CITY OF ALBUQUERQUE

Re: Martinez Car Lot
1021 Coors Rd. SW
Traffic Circulation Layout
Engineer's/Architect's Stamp 11-17-18 (L11D023)

Based upon the information provided in your submittal received 12-3-18, the above referenced plan cannot be approved for Building Permit until the following comments are addressed:

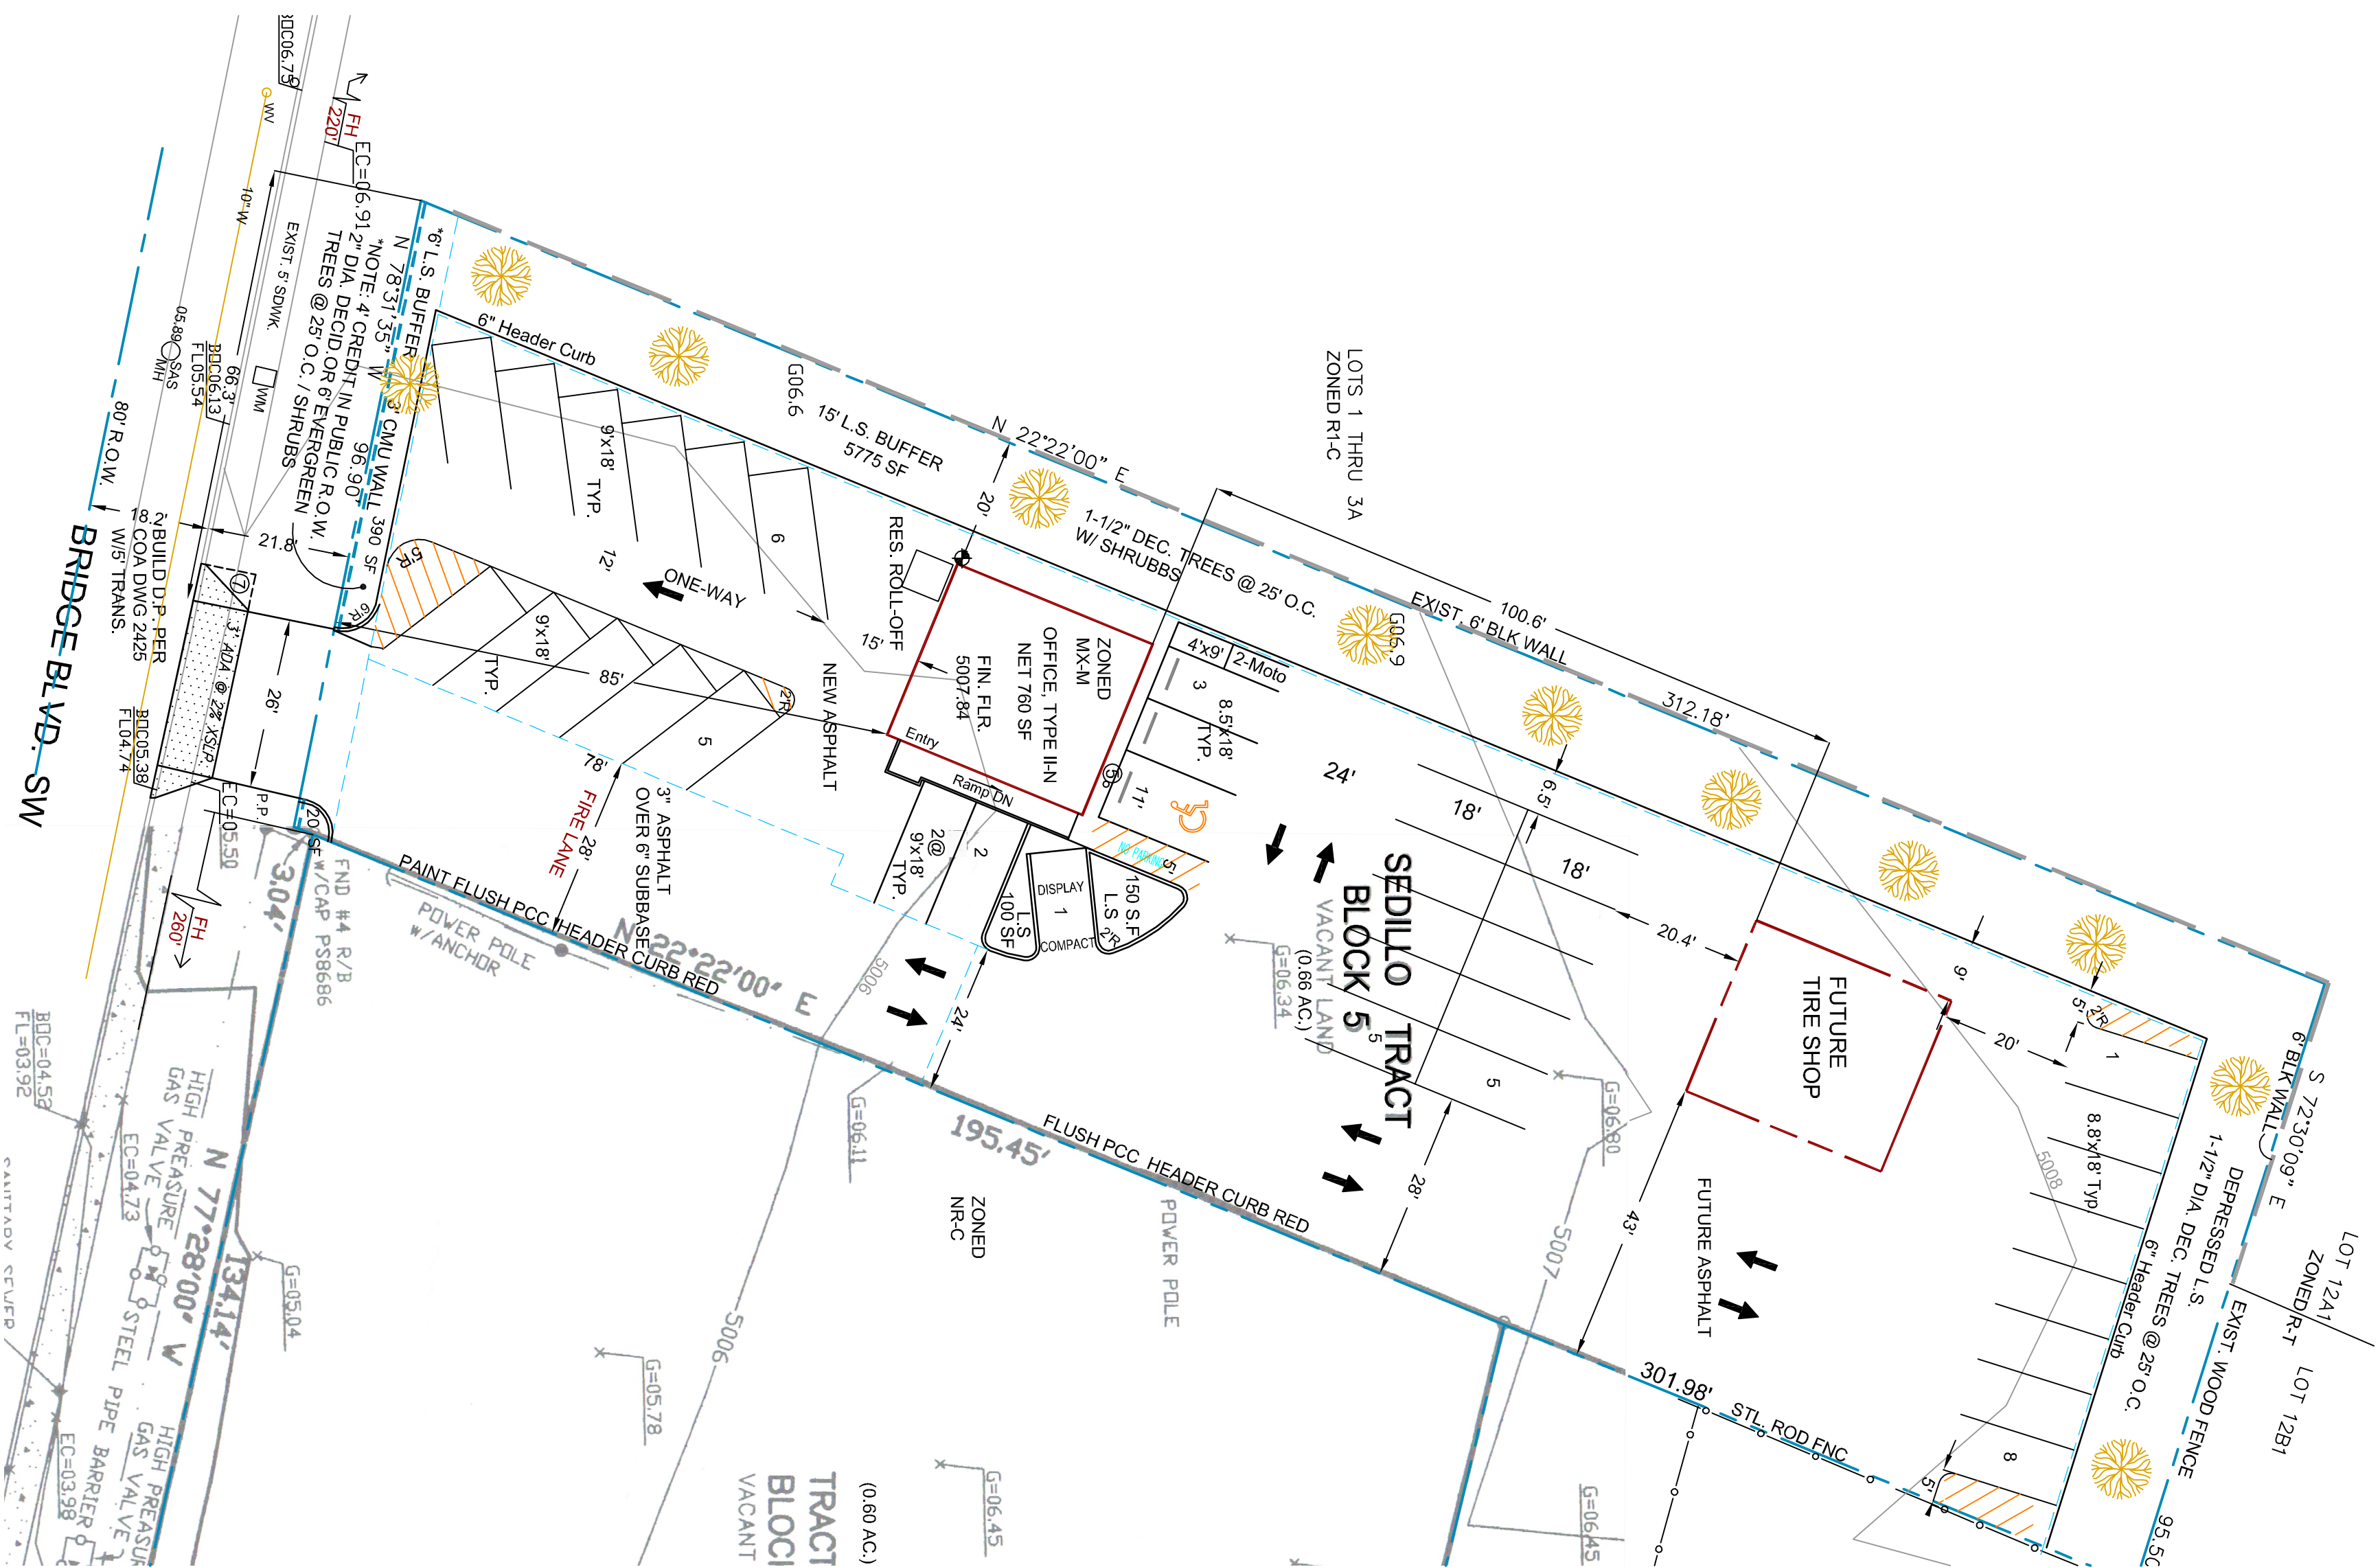
1. List the number of parking spaces required by the IDO as well as the proposed number of parking spaces including bicycle and motorcycle parking.
2. Please list the width and length for all existing and proposed parking spaces. Some dimensions are not shown.

3. The ADA access aisles shall have the words **"NO PARKING"** in capital letters, each of which shall be at least one foot high and at least two inches wide, placed at the rear of the parking space so as to be close to where an adjacent vehicle's rear tire would be placed. (66-1-4.1.B NMSA 1978)

4. Motorcycle parking spaces shall be designated by its own conspicuously posted upright sign, either free-standing or wall mounted per IDO.
5. Please revise motorcycle parking stalls

6. Per the IDO, a 6 ft. wide ADA accessible pedestrian pathway is required from the public sidewalk to the building entrances. Please clearly show this pathway and provide details.

7. Service vehicle and/or refuse vehicle maneuvering must be contained on-site; provide a copy of refuse approval.
8. One-way vehicular paths require pavement directional signage and a posted **"Do Not Enter"** sign at the point of egress. Please show detail and location of posted signs.

9. Please add a note on the plan stating "All improvements located in the Right of Way must be included on the work order."
10. Please revise parking on SW corner.

11. Please indicate what parking is being used for display.

12. Please include one copy of the traffic circulation layout at the next submittal.
